DESC.	Mini SAS HD 4x to QSFP CABLE ASS'Y		APPROVED	CHECKED	DESIGNED	TOLERANCE	SCALE	*	UNIT	mm	
P/N	C5597-0.5M	CUSTOMER P/N	C5597-0.5M				Sino		DATE	11/05/'19	DWG NO:

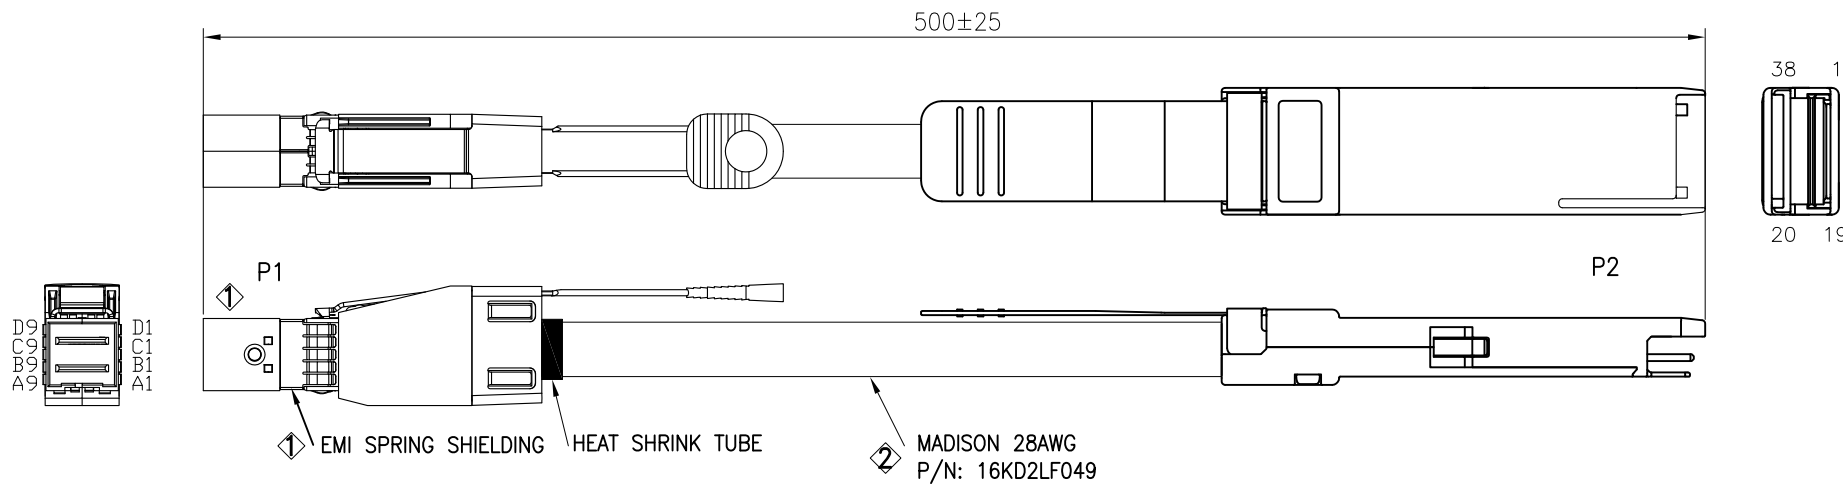
1	2	3	4	5	6	7	8	9
REV.	REMARK			DATE	SIGN.	RoHS		
①	CHANGE CONNECTOR & PCB			01/31/'13	Sino			
②	CHANGE CABLE			04/16/'14	Sino			
③	REVISE PCB P/N, UPGRADE FOR SAS 12G, USE AT24C02D EEPROM			11/05/'19	Sino

1. CABLE:
- ① CONDUCTOR: 28AWG SOLID SILVER PLATED COPPER.
 - INSULATION: FOAM POLYOLEFIN.
 - PAIR: 2 SINGLES LAID FLAT AND PARALLEL.
 - CORE: 8 PAIRS
 - PAIR DRAIN WIRE: 30AWG SOLID TIN PLATED COPPER.
 - PAIR SHIELD: ALUMINUM/POLYESTER TAPE. ALUMINUM SIDE FACING IN, 25% OVERLAP.
 - INNER SHIELD: ALUMINUM/POLYESTER TAPE, ALUMINUM SIDE FACING OUT, 25% OVERLAP.
 - OUTER SHIELD: 38AWG TIN PLATED COPPER BRAID, 85% COVERAGE.
 - JACKET: FLEXIBLE PVC, COLOR - BLACK.
 - DIAMETER: 7.88±0.25mm
 - PRINT LEGEND: "MADISON CABLE {Mfg. Location Code} (UL) TYPE CL2 75°C 28AWG CSA AWM II A/B 75°C 30V FT4 TurboTwin™ SUBSTANCE COMPLIANT 2011/65/EU {D/C}"
 - DIFFERENTIAL IMPEDANCE: 100±5 OHMS @TDR
 - UL LISTING: TYPE CL2 AS SPECIFIED IN ARTICLE 725 OF THE NATIONAL ELECTRICAL CODE.

- P1: Mini SAS HD 4x CABLE PLUG (SFF-8644)
- ① P.C.B: 4 LAYERS, GOLD PLATING ON CONTACT PADS (P/N: MPCB-040091LF REV.F / SPCB-040092A REV.F)
 - ② LATCH: STAINLESS STEEL
 - ③ BACKSHELL: ZINC DIE CASTING HOOD/ NICKEL PLATING
 - ④ PULL TAB: NYLON UL94V-0, COLOR: BLUE.
 - ⑤ EMI SPRING SHIELDING

- ③ 3. Mini SAS HD 4x TWO-WIRED SERIAL MEMORY: ATMEL AT24C02D EEPROM (256 BYTES).
- ③ 4. QSFP TWO-WIRED SERIAL MEMORY: ATMEL AT24C02D EEPROM (256 BYTES), DIGITAL MONITORING, CONTROL FUNCTION AND MEMORY PAGE NOT SUPPORTED.
- ③ 5. FOR SAS 12.0 Gbps.
